SUBJECT: Customer Satisfaction Program 21N01
Certain 2016-2018 Model Year Explorer Vehicles
High-Speed Cooling Fan Motor Relay

CERTAIN 2016-2018 MODEL YEAR EXPLORER BJB VEHICLES — HIGH SPEED COOLING FAN MOTOR RELAY

FIGURE 1

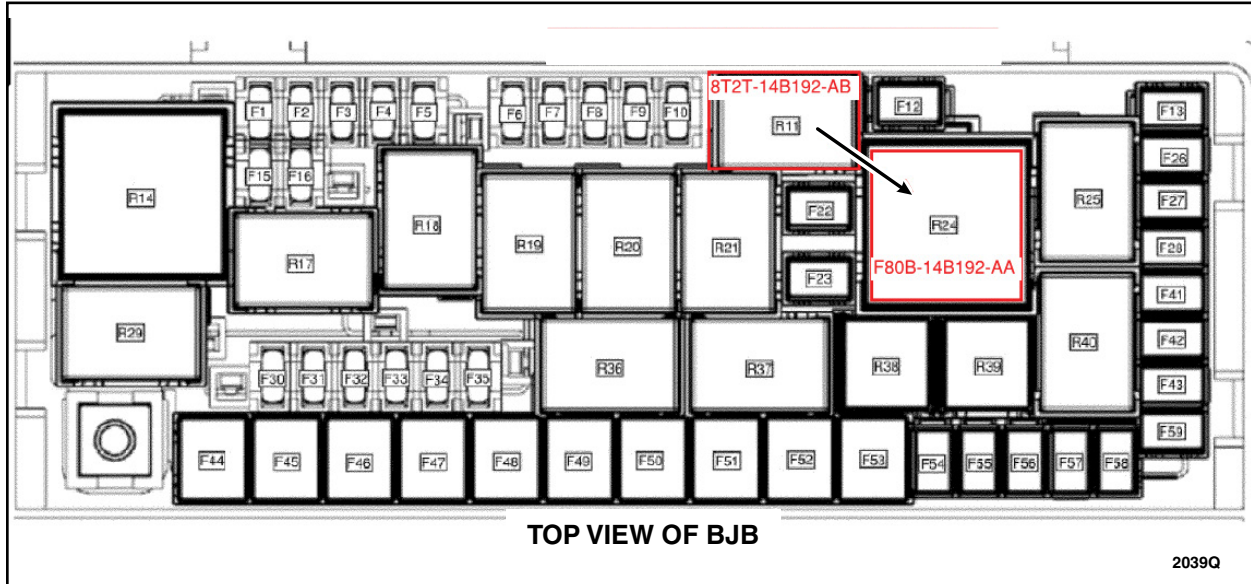
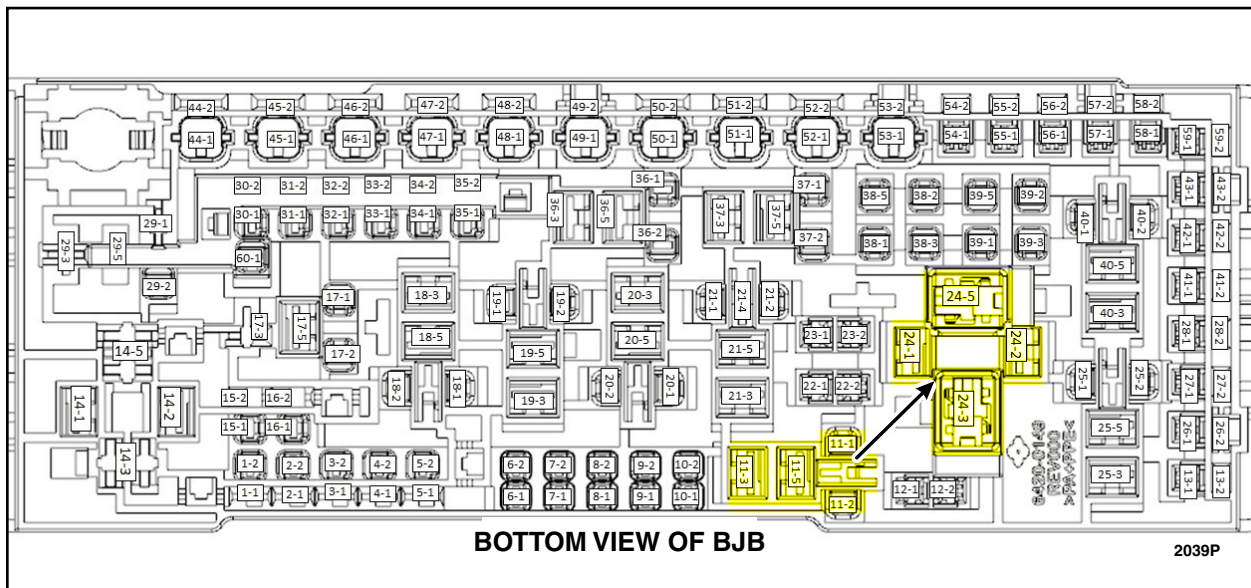
NOTE: The high speed cooling fan relay (R11) will be relocated to the (R24) position in the Battery Junction Box (BJB) as shown in Figures 1 and 2.

FIGURE 14

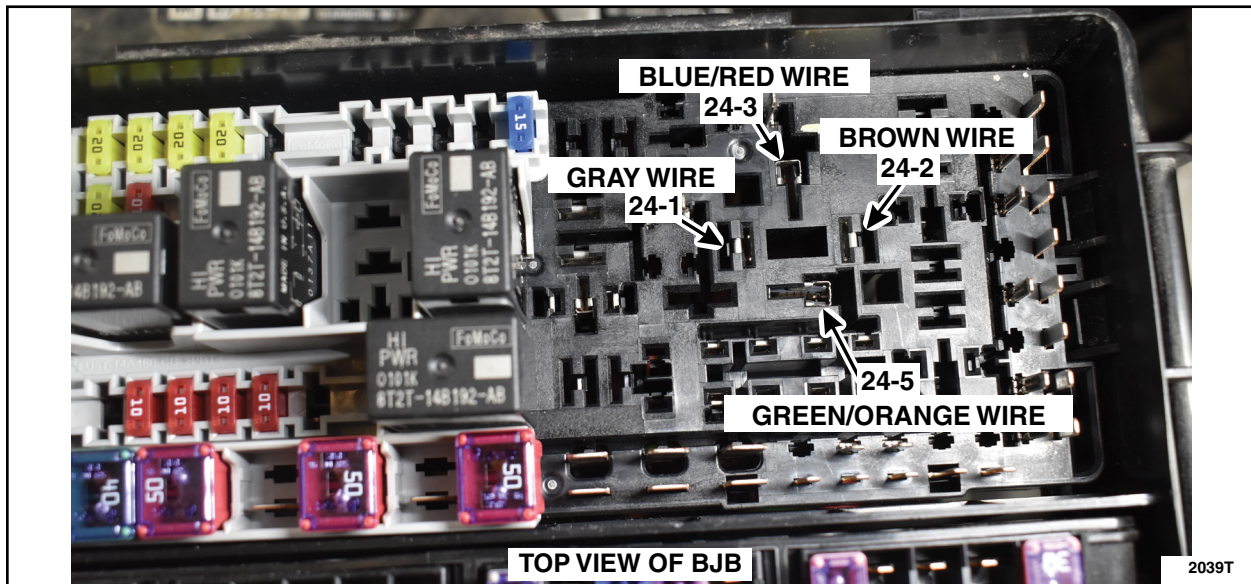
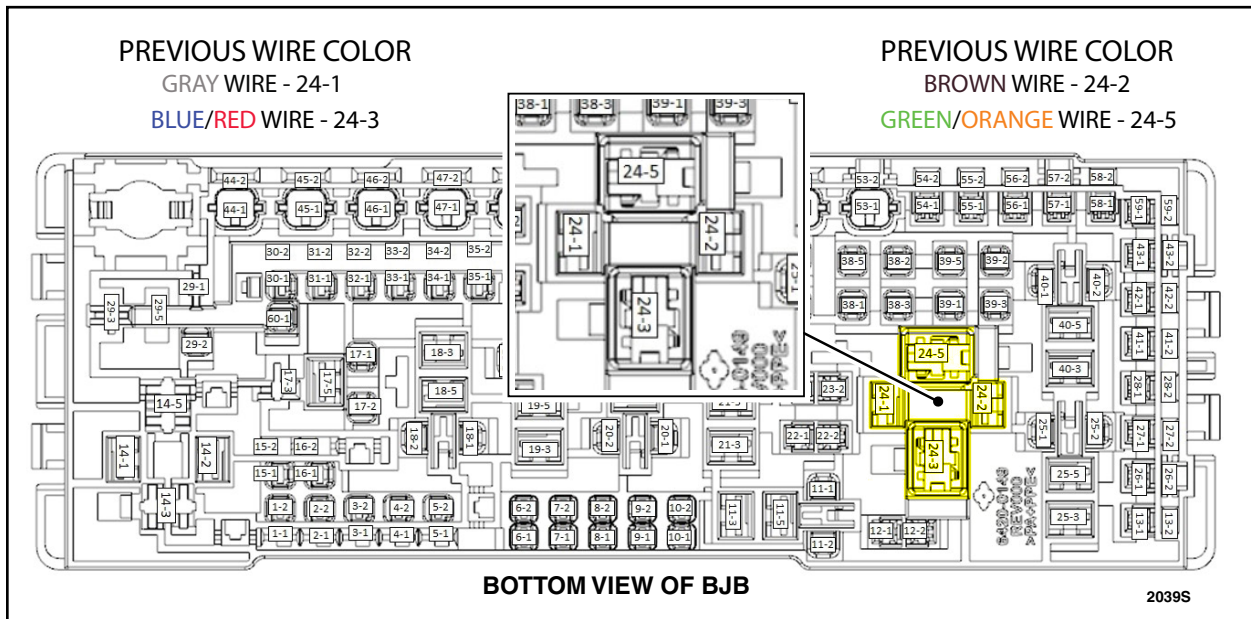
10. Install the four (4) wires, removed from the original relay with *new* terminal ends, into the *new* relay R24 cavities as noted below. See Figures 14 and 15.

- Install what was the original gray wire into cavity 24-1.
- Install what was the original brown wire into cavity 24-2.
- Install what was the original blue/red wire into cavity 24-3.
- Install what was the original green/orange wire into cavity 24-5.
